United States Department of the Interior

Re: Draft Engineering Evaluation/Cost
Analysis for MEC Removal, Solid Waste
Management Site Unit 4, Former Naval
Ammunition Support Detachment, Vieques,
Puerto Rico

This is to comment on the December 2005, draft Engineering Evaluation/Cost Analysis (EECA) for Munitions of Explosive Concern (MEC) Removal for Solid Waste Management Unit 4 (SWMU 4). This action is intended to remove the potential hazards associated with MEC at the site and remove MEC and MEC-related material.

Figure 1. Pink areas show large buried anomalies many of which are not associated with OB/OD pits (odd shaped black numbered polygons). The investigation of these anomalies has been requested several times in the past.

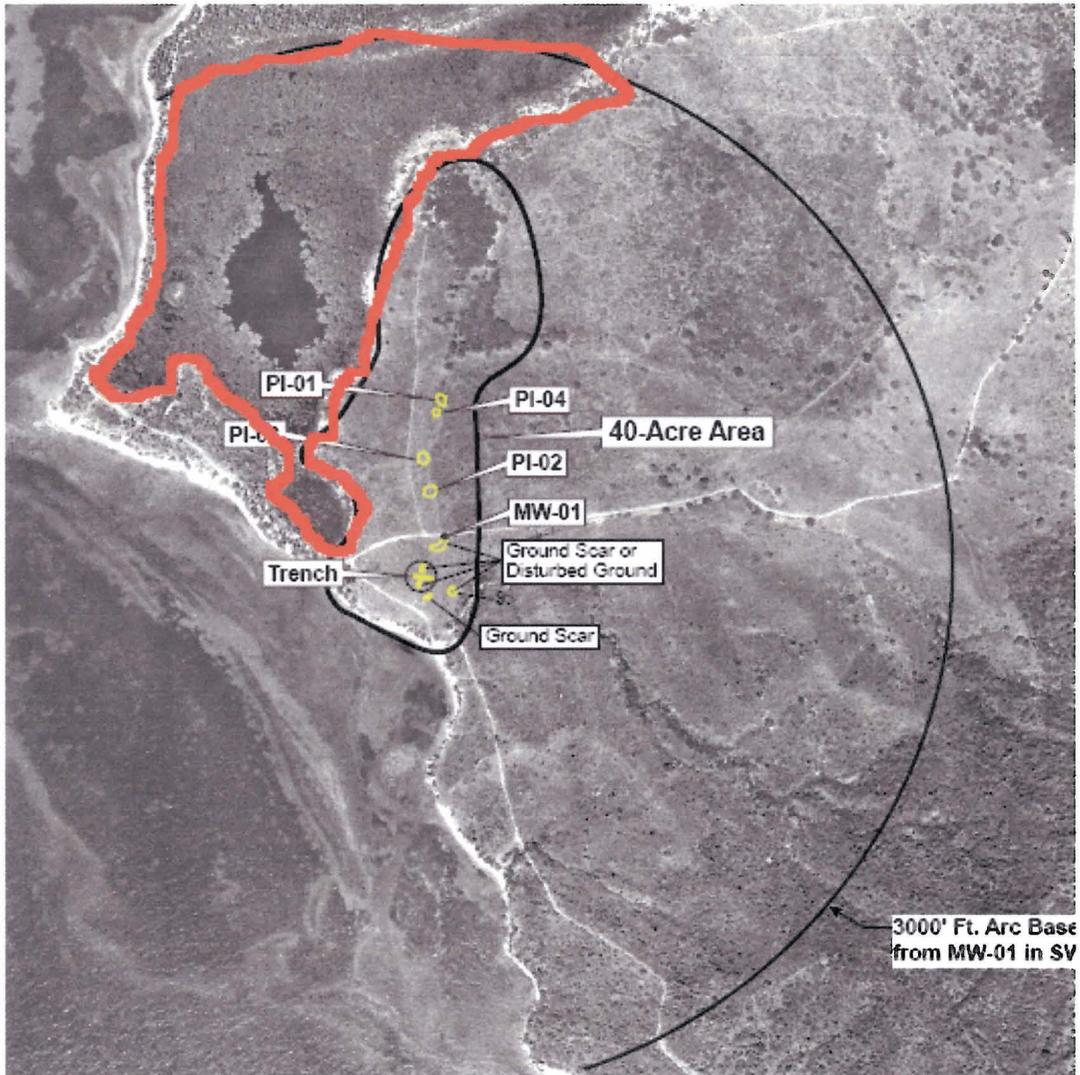
2) The EECA does not address the presence of several large subsurface anomalies found on the site. These anomalies are not associated with the known OB/OD pits and should be investigated as part of this non time critical removal action (see Figure 1). The Service has recommended that these anomalies be investigated and the response has been that it would be done at some future time. We believe that this would be an excellent time to do this.
